Stay Arm Warning Labels

TITLE: Front Emergency Glad-hand Air Circuit Rework

3 - Stay Arm Warning Labels

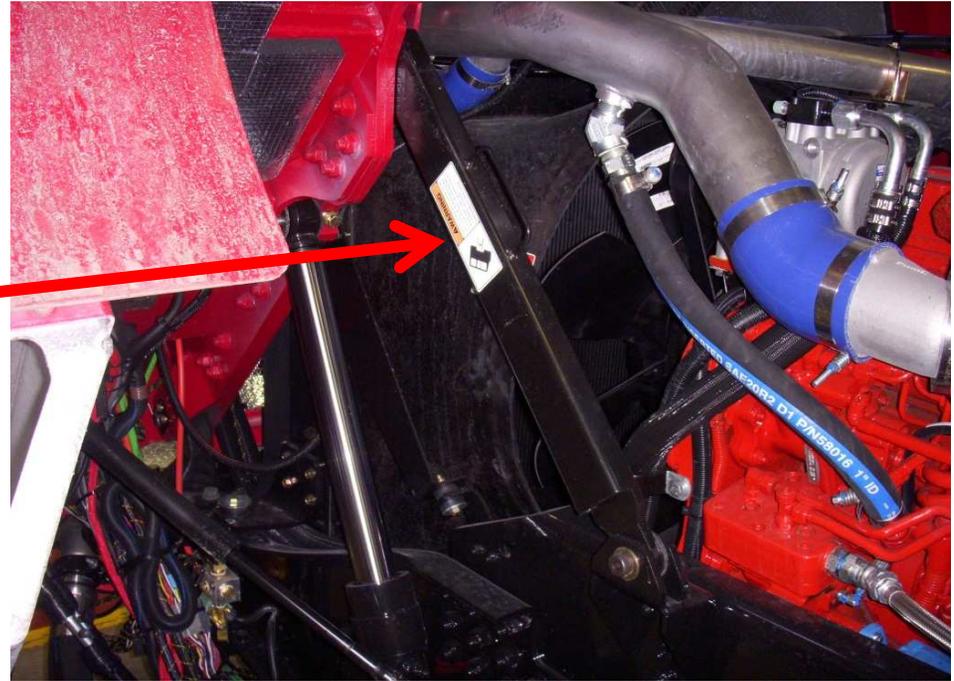
Warning labels need to be added to instruct users that when the cab is tilted the stay arm needs to be engaged. These labels are to be added to the stay arm and the cab tilt controls.

4 Apply Warning Label on the visible side of the stay arm as shown

5 Apply second warning label on or near the cab lift controls.
